Projet minier aurifère Canadian Malartic

**Addendum  
au plan de restauration du  
site minier Est-Malartic**

**Objet. : Addendum au plan de restauration du site minier Est-Malartic**

**Objet :** Réponses aux questions contenues dans les avis du MEF et du MRN reçus le 15 septembre 1998 et concernant le plan de restauration du site minier Est-Malartic soumis au MRN le 8 avril 1996

Feuille 1/1 Révisé le 22/3/96 **FIGURE 1.2**  
 Réf. micro C6552LIM.DWG

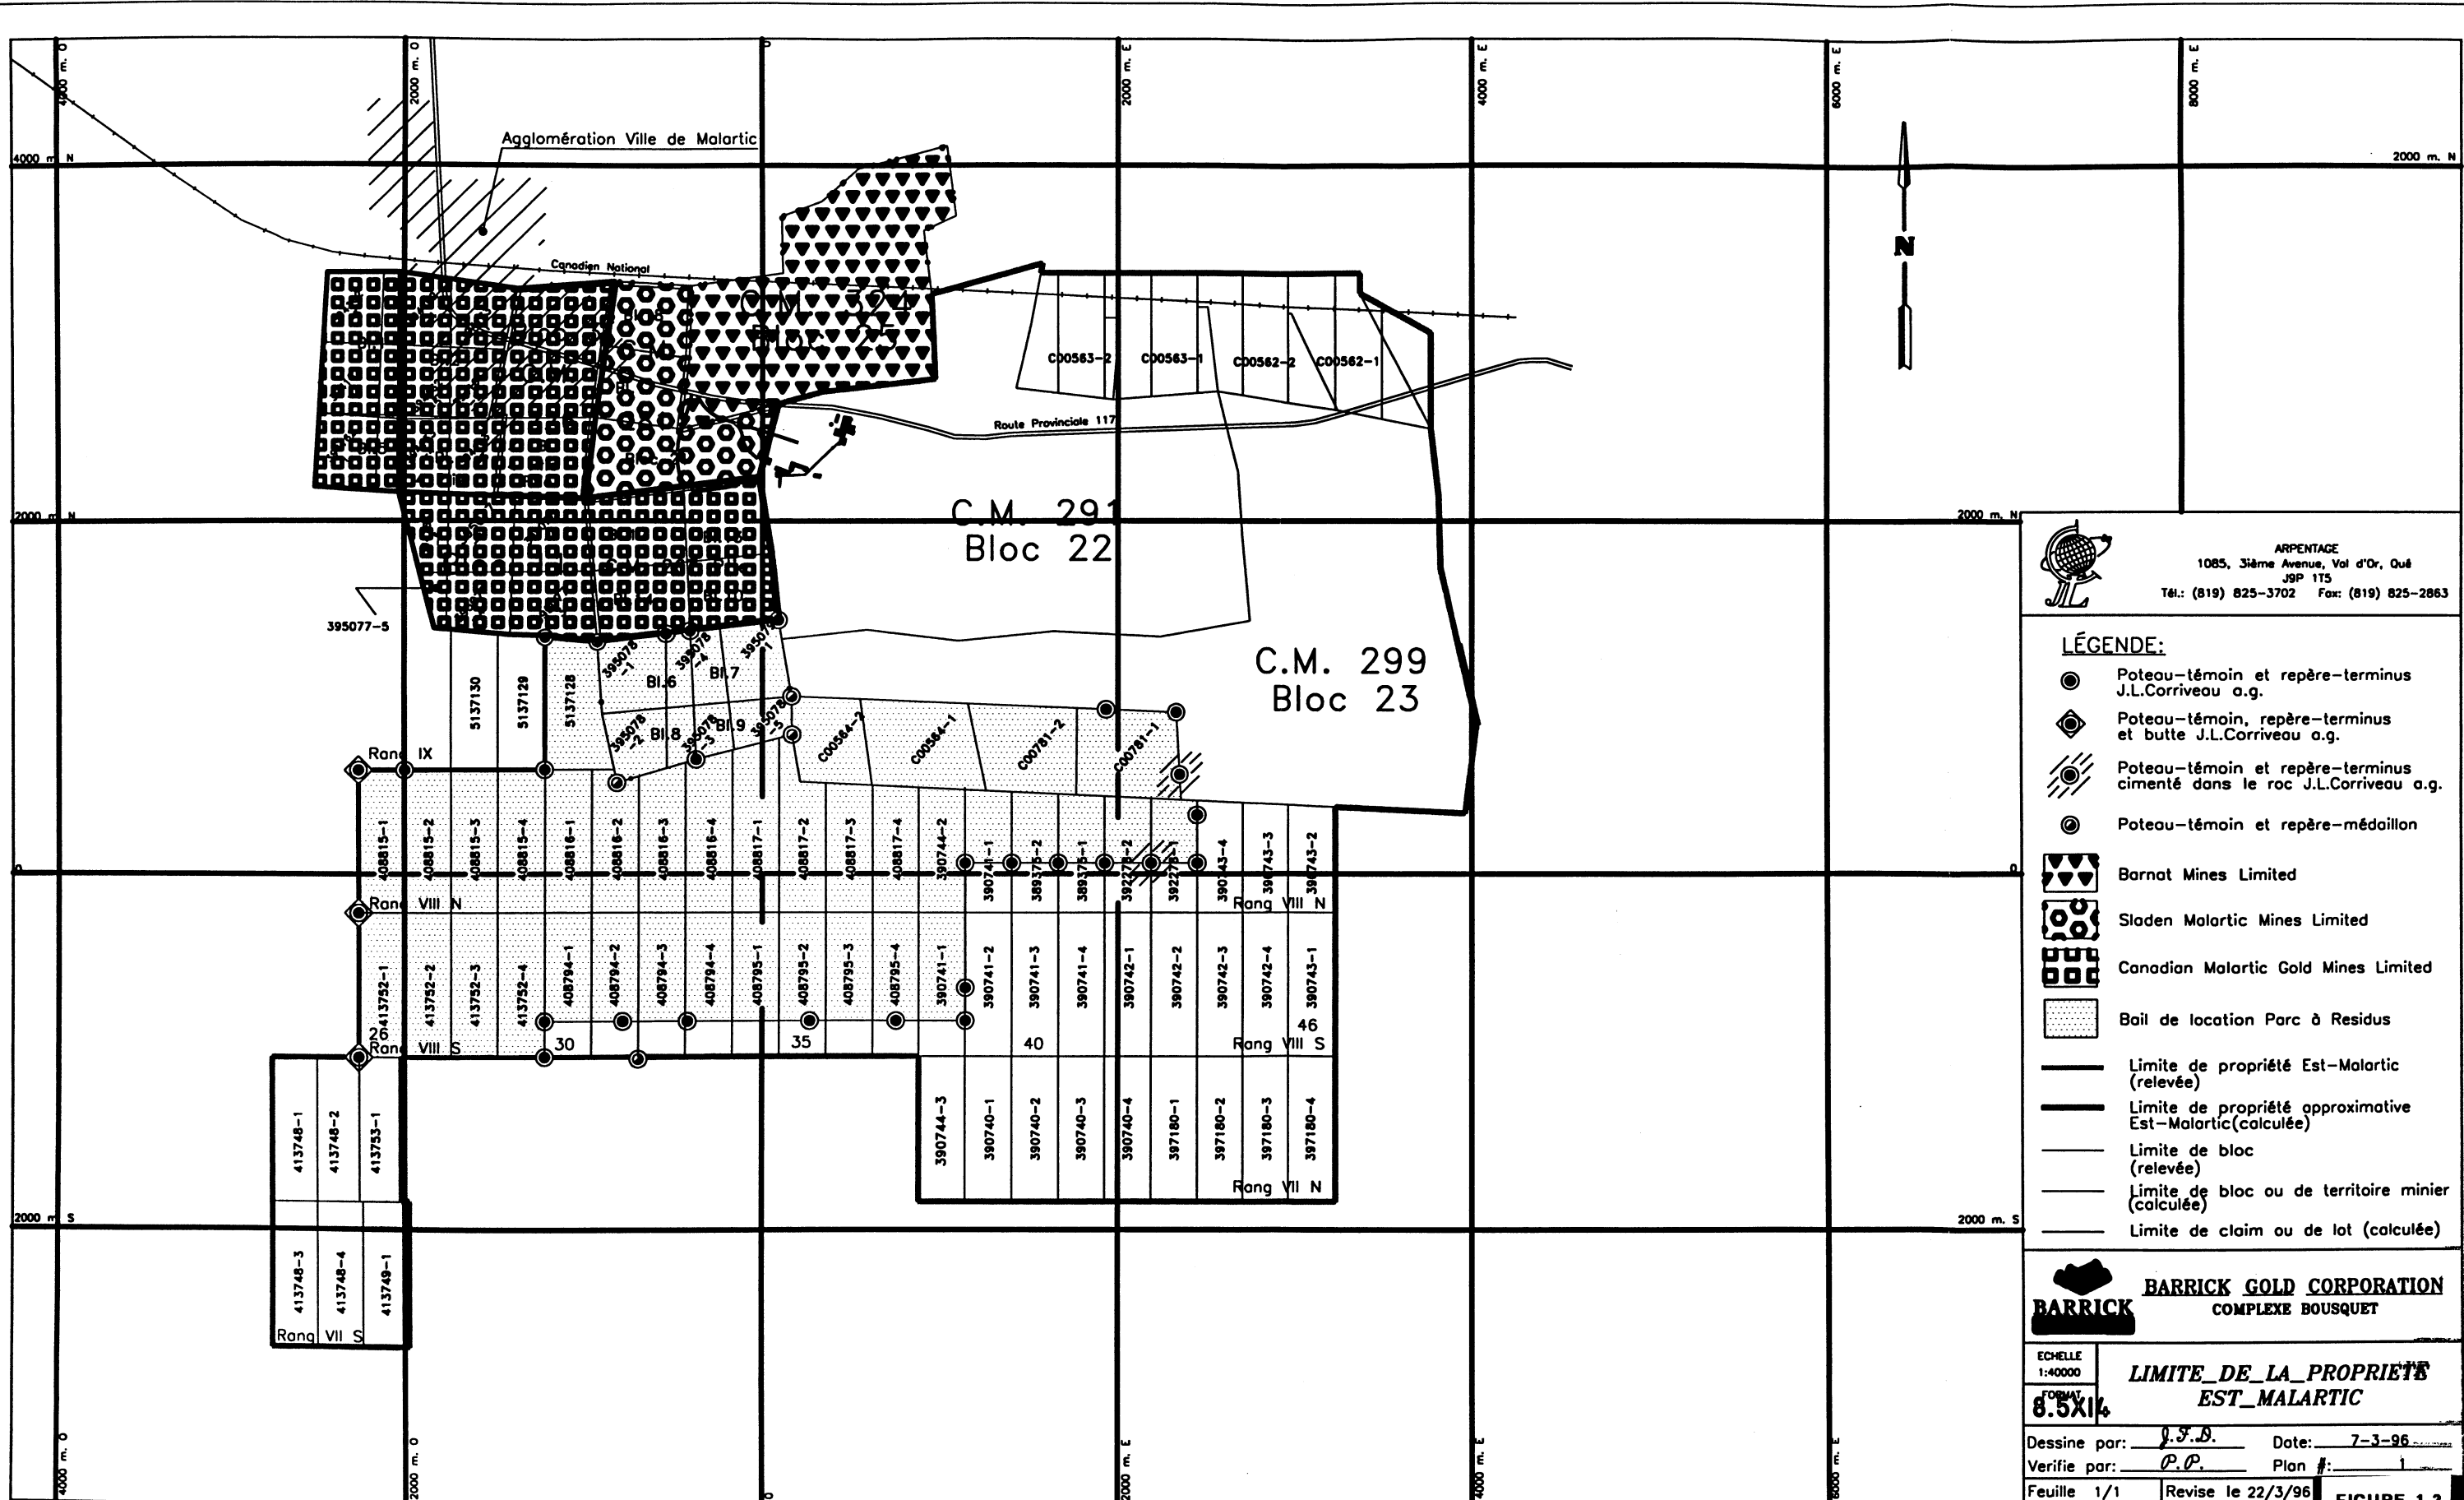
2) 1.7 « Concernant la propriété, la figure 1.2 indique que la CM-267 ne fait pas partie de la propriété (malgré ce que dit le tableau 1.2); par contre, les 6 claims 395078-1 à 5 et 395079-1 en font partie (malgré qu'ils sont hachurés comme faisant partie de Canadian Malartic) »

Vous trouverez, à l'annexe 2 de ce document, une copie révisée du tableau 1.2, « Liste des claims pour la propriété Est-Malartic », ainsi qu'une copie révisée de la figure 1.2, « Limite de la propriété Est-Malartic ». Tel que vous l'avez remarqué, la CM-267 fait partie de la propriété Canadian Malartic Gold Mines Limited alors que les 6 claims 395078-1 à 5 et 395079-1 font partie du parc à résidus de la propriété Est-Malartic.
